LACP state machines revisited

Mick Seaman

This note is a snapshot of a further critical examination of the current LACP machines. LACP was the first significant 802.1 effort using the current state machine conventions, and perhaps unsurprisingly did not follow them as strictly as later work (such as RSTP/MSTP for example). These machines may need further work, but should be of interest to others working on P802.1AX-Rev.

LACP State Machine Overview

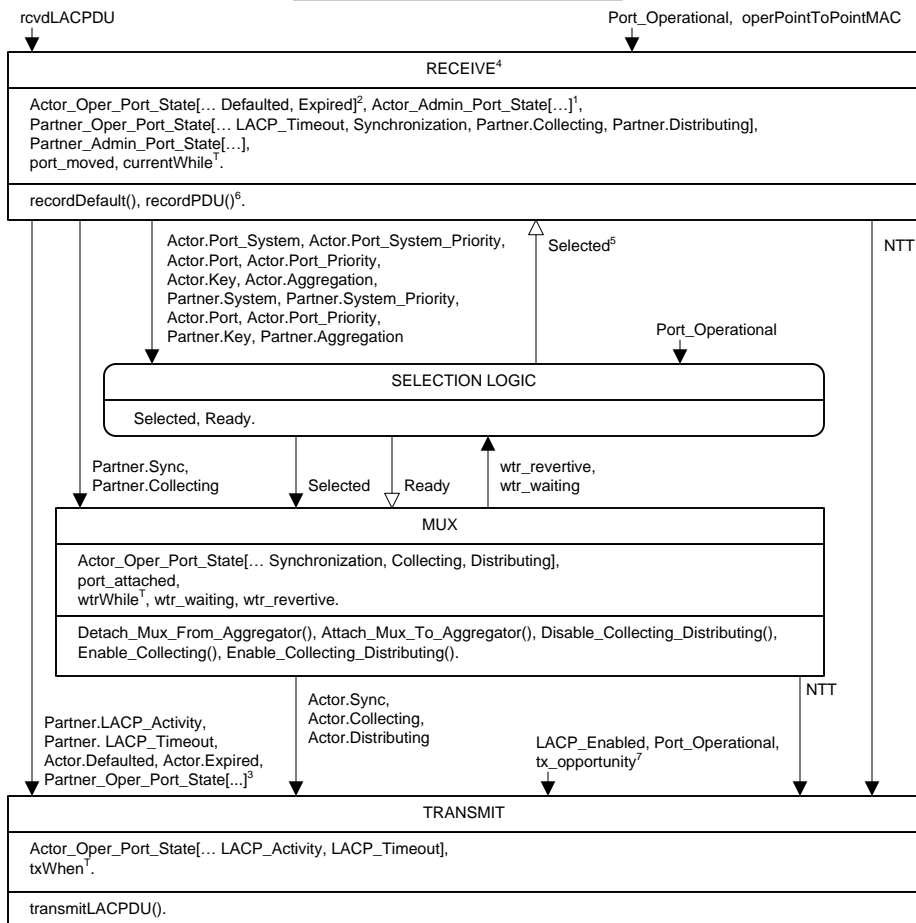
The Churn machines have been removed. They were a nice idea but don't do much or work as originally intended.

The TRANSMIT and PERIODIC machines have been combined, as they clairvoyant (aware of each other's state without using any communication variables). The combination is simpler and sends fewer unnecessary LACPDUs.

This figure is not a state machine, but an informal overview of the basic LACP state machines, their state variables, and the use of variables to communicate between machines. It follows the general style of IEEE 802.1Q Figure 13-13's overview of RSTP/MSTP, though is simpler and has conventions adapted for LACP description. It could be a more informative replacement for 802.1AX Figure 6-18, but was produced simply to aid the author's own understanding.

Three per port state machines (RECEIVE, MUX, and TRANSMIT) are shown [the 802.1AX-2014 PERIODIC state machine is considered to be part of the TRANSMIT state machine, for reasons detailed elsewhere] together with the SELECTION LOGIC (which operates over all ports, shown in the figure with the set of variables for a single port – omitting the identifier of that port and the identifier of the aggregator to which it might be attached).

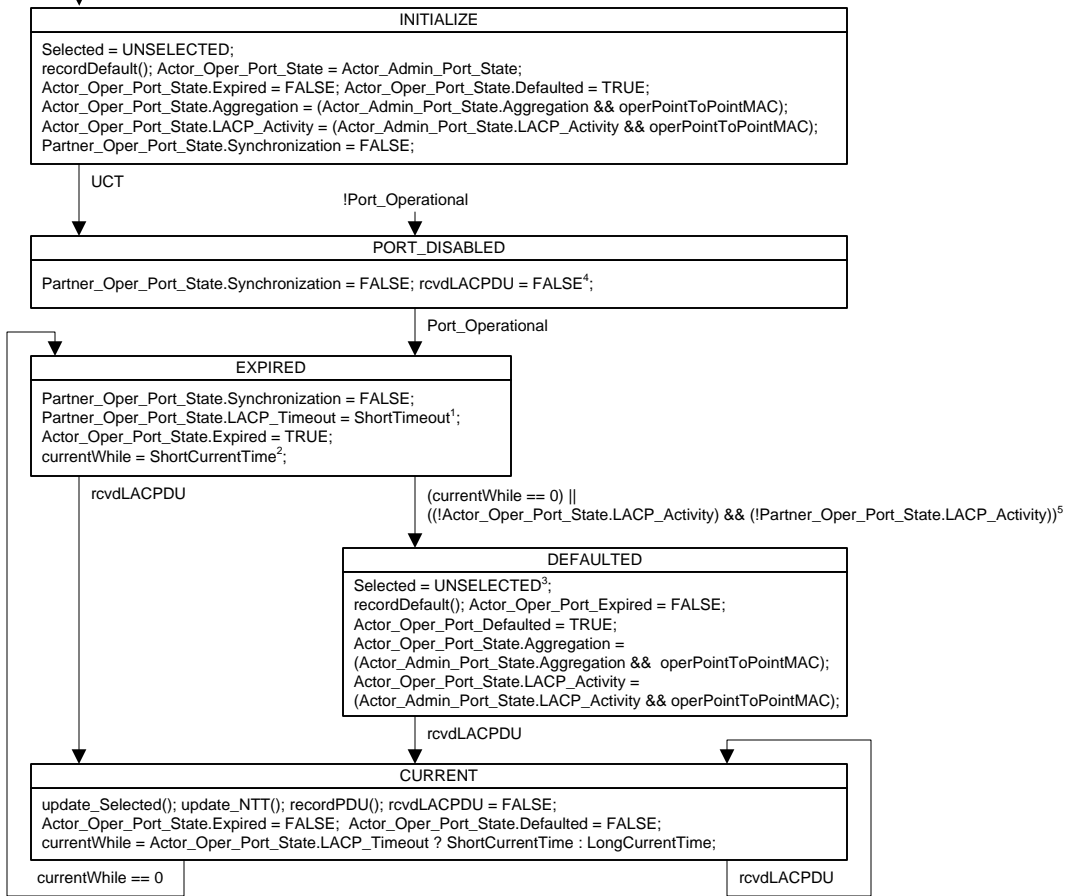
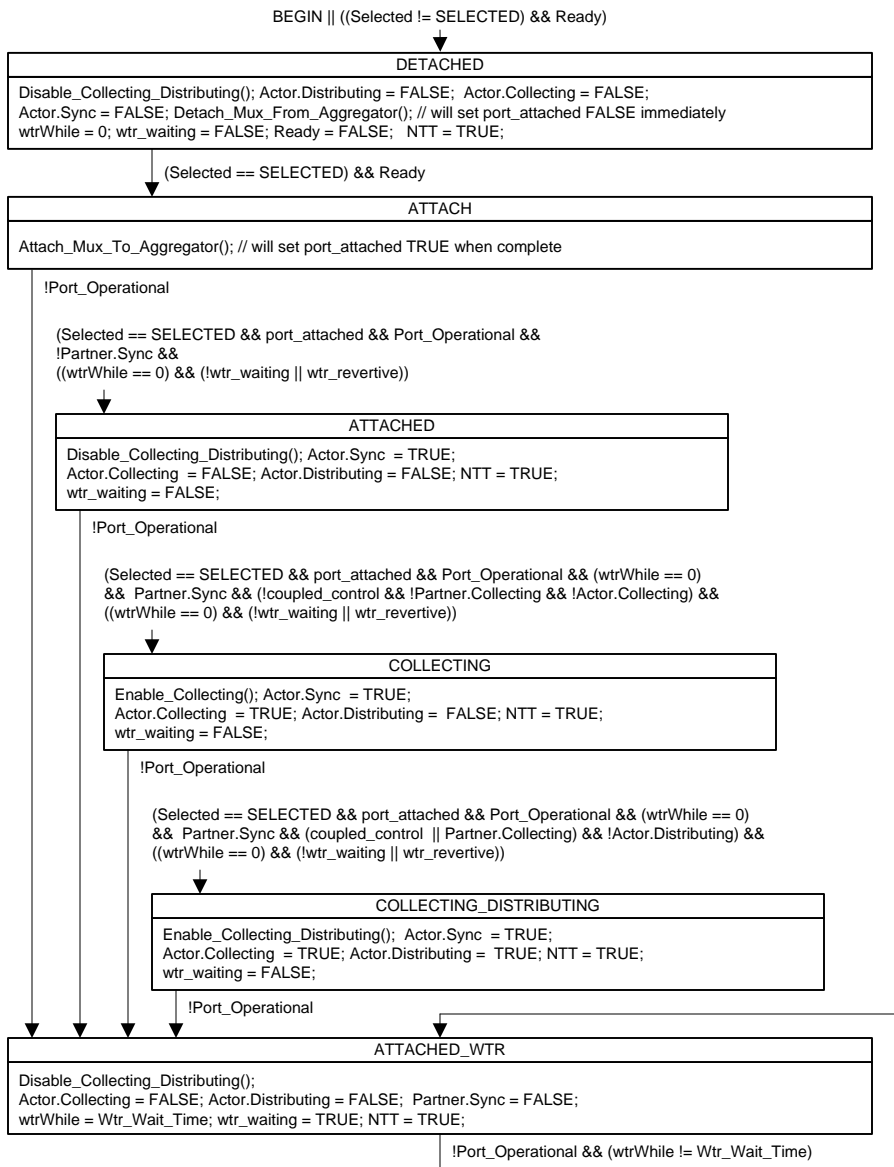
A suggested replacement for the 802.1AX-Rev D0.1 machine, may need further updating when that draft is updated. Intended to fix problems with the D0.1 port_moved variable (by removing it) and with LACP_Enabled (replaced by operPointToPointMAC), see discussion below.

D0.1 port_moved problems: 1. The !Port_operational && !port_moved transition to PORT_DISABLED would be defeated if port_moved could be set in any of the other states, either when Port_Operational is still true or before this state machine acts on the transition. The state machines do not provide any way to avoid the later possibility even if all the state machines for all ports operate mutually exclusively (an unrealistic constraint in a large system). 2. If the defaults for this port cause the conflict with the other port then the port_moved transition to INITIALIZE will be executed for every LACPDU received on the other , but without any useful effect. 3. Since Partner.Sync will be cleared on !Port_Operational and not set again until Port_Operational and receipt of a LACPDU, port_moved doesn't make any additional contribution to preventing unwanted connectivity, though the execution of INITIALIZE does remove potentially useful management information.

D0.1 LACP_Enabled problems: The name and description of this variable confused the possibility of link aggregation (deemed impossible, or at least undesirable to the extent it should be prevented, for non-point-to-point links) with sending and receiving LACPDU. The description also implied that LACP_Enabled could combine further management controls. Curiously LACP_Enabled could be set without asserting BEGIN, but not cleared. This suggested machine adopts the point of view that management control is exerted by changing the value of Actor_Admin_Port_State.LACP_Enabled, while operPointToPointMAC clears the corresponding Oper state. The D0.1 machine assumed that both ends of the link saw the same value for operPointToPointMAC, which is not necessarily the case if there are intervening lower level bridges (such as TPMRs). This machine therefore clears Actor_Oper_Port_State.Aggregation (rather than Partner_Oper_Port_State.Aggregation) for non-point-to-point links. That change means the Actor's decision about aggregatability can be communicated to his Partner, which is useful as a LACP capable partner can then attach the link (as an individual link) without delay. Since the LACP_DISABLED has been removed there is no need to add an explanation how any received LACPDU are handled in that state. To avoid sending LACPDU on links which the Actor and all potential partners believe to be non-point-to-point it sets the Actor PASSIVE i.e. FALSE when operPointToPointMAC is FALSE.

Assignments to Actor_Oper_Port_State.Defaulted are shown explicitly, rather than hidden in recordDefault(). The D0.1 state machine kept Defaulted TRUE in CURRENT.

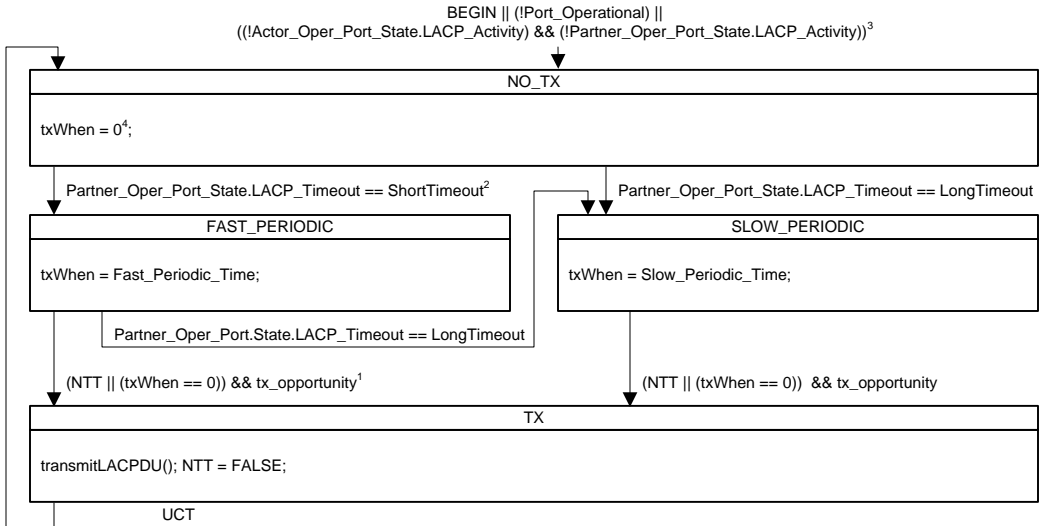
This machine reflects what (I believe) was agreed in July, i.e. the machine waits in ATTACHED_WTR until the Selection Logic sets Selected to UNSELECTED even if wtr_revertive is FALSE.

This version of the machine uses a separate wtr_waiting variable in addition to wtr_revertive (selection of revertive mode vs non-revertive mode) and the wtrWhile timer (which can be zero in ATTACHED_WTR if Port_Operational has been set for the required time but non-revertive mode has been selected). The Selection Logic can use wtr_waiting as an indication that the machine is in ATTACHED_WTR, and stuck there is non-revertive. The mode variable wtr_revertive can be changed by management at any time without additional operations or disruption of machine operation.
